ENERGY STAR® Draft 3 Version 2.0 Commercial Dishwasher Specification

Stakeholder Webinar

October 18, 2011

Section 3: Revised Performance Levels

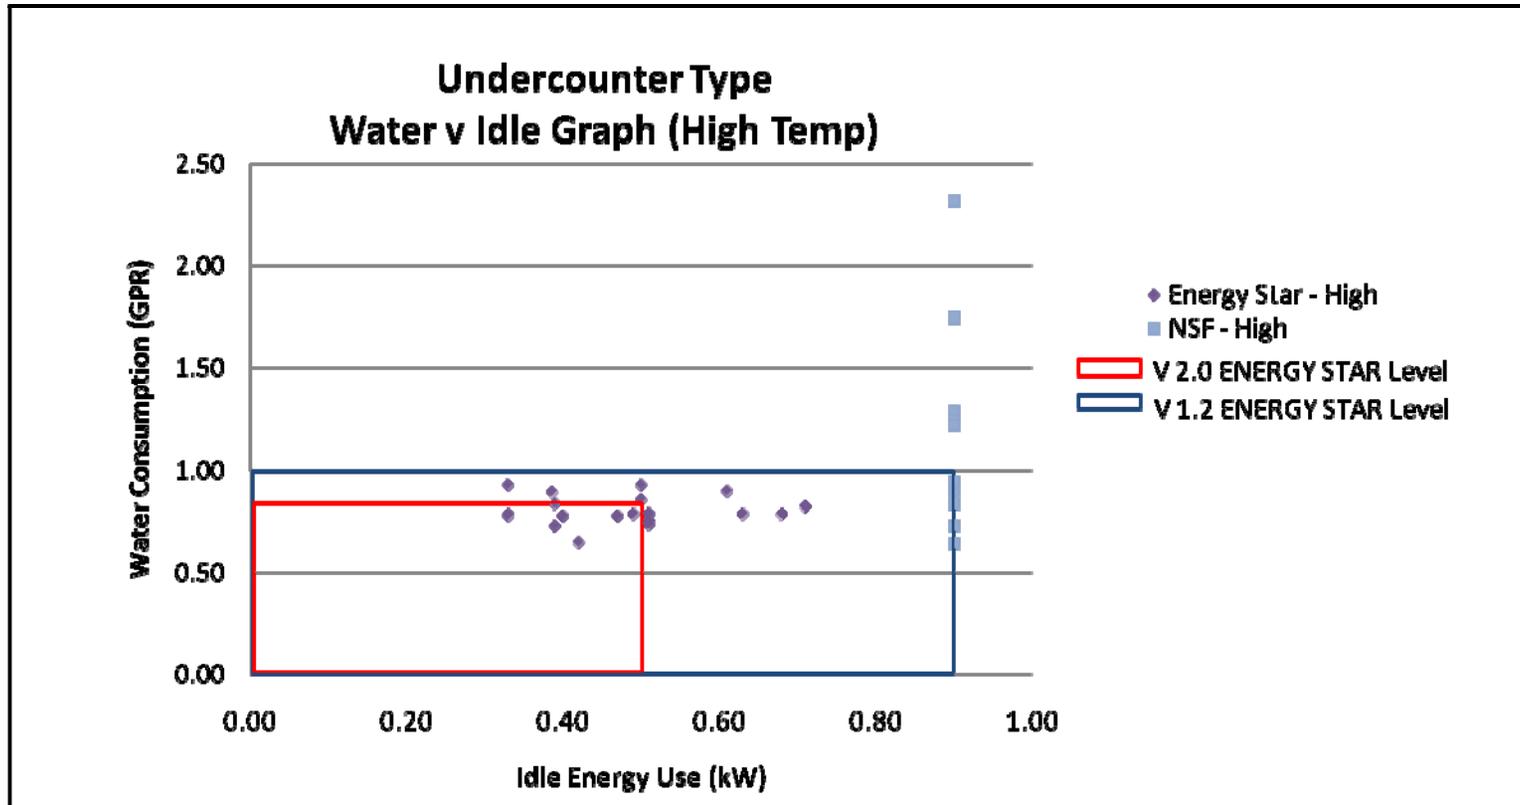
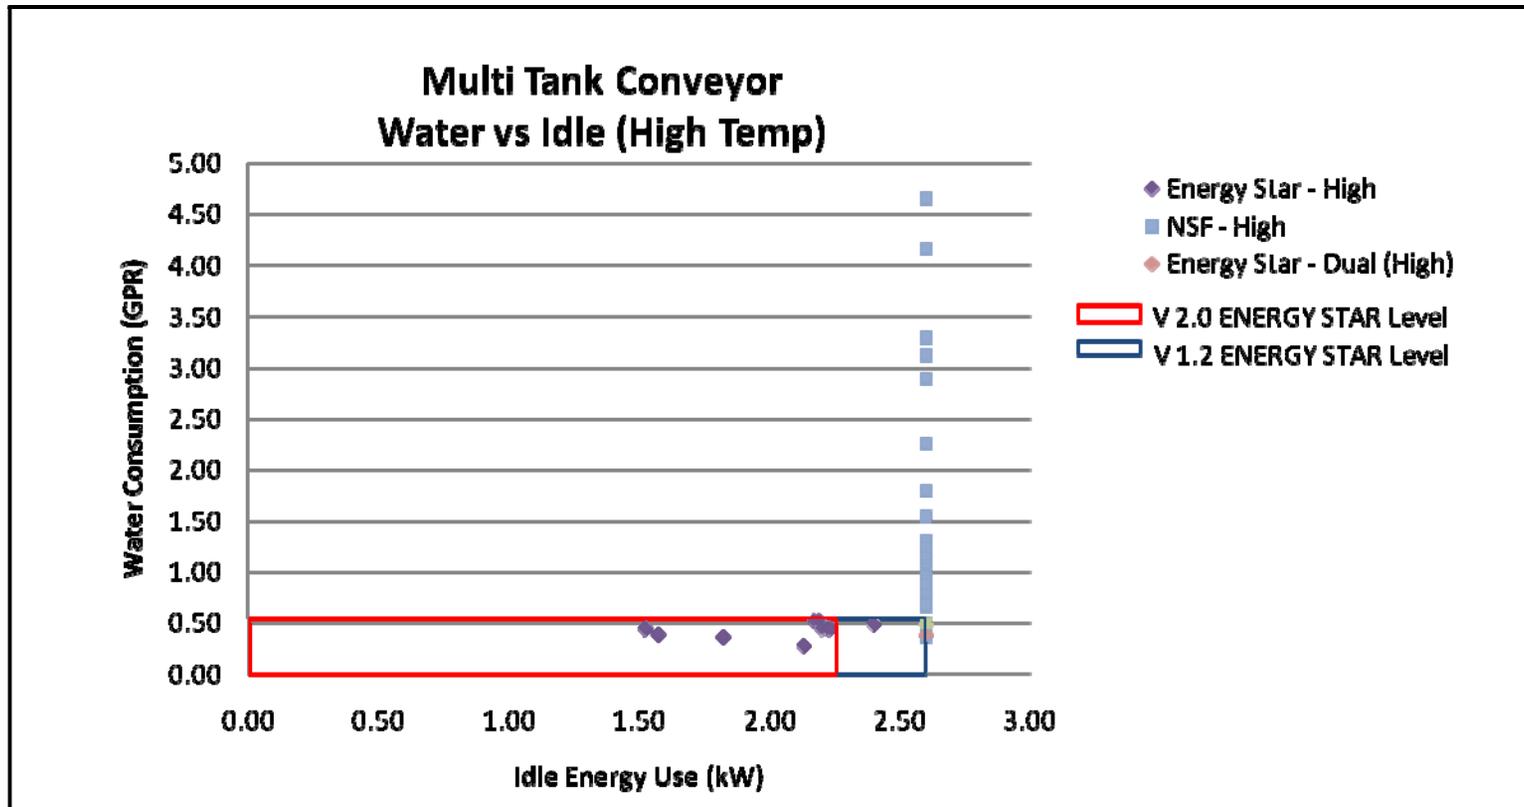
- New GPR level for HT under counter machines
 - 0.86 to 0.84, qualification rate = 26%
- New idle energy rate for HT multiple tank rack conveyors
 - 2.00 to 2.25 kW, qualification rate = 21%

HT Door Type Graph

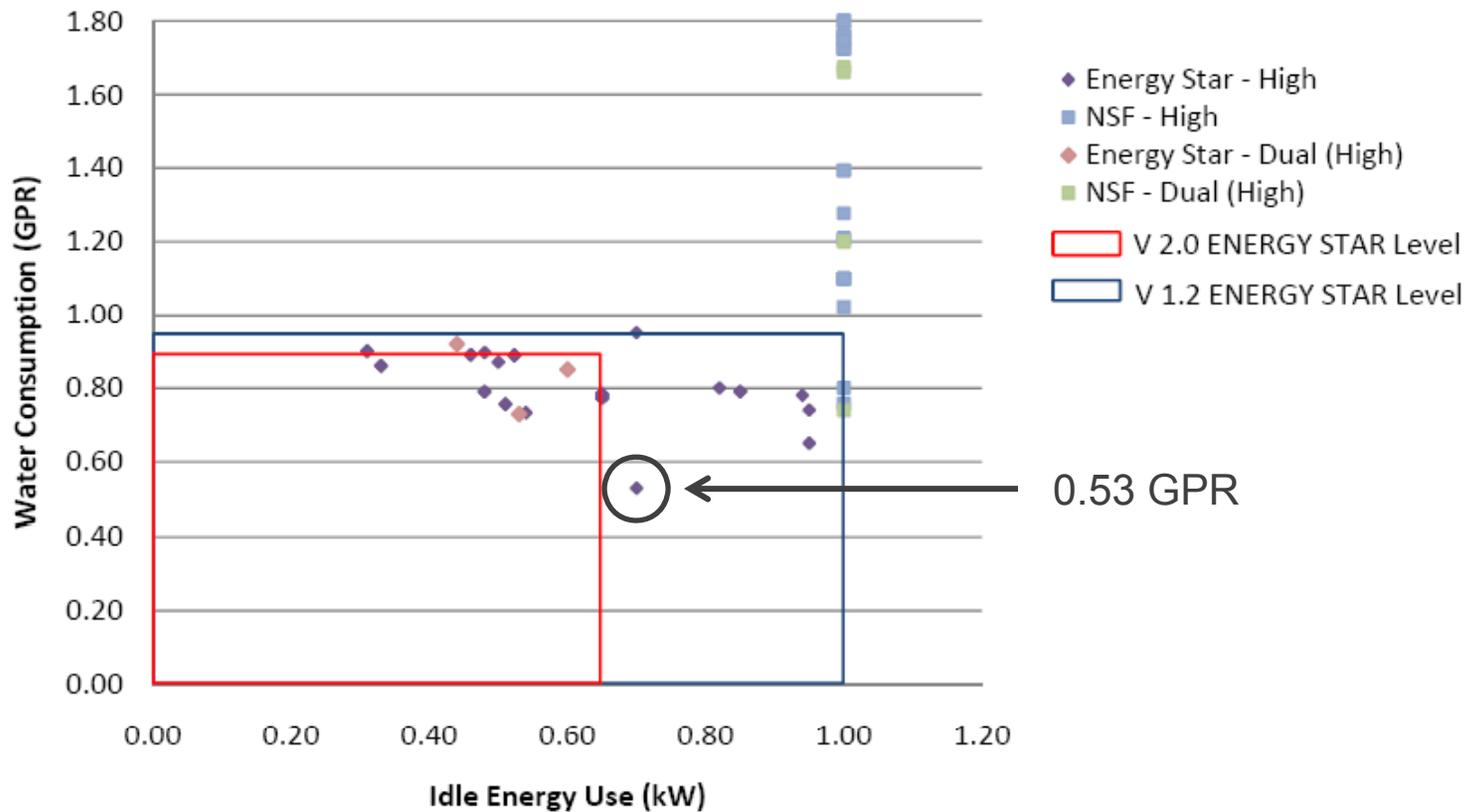
- Reducing idle for door type machines from 1.0 to 0.64 kW would exclude the most water efficient designs
 - Increase idle to 0.7 kW to include this model
 - EPA considering this change, recognizing that greater energy savings will be garnered through reduction of rinse water consumption
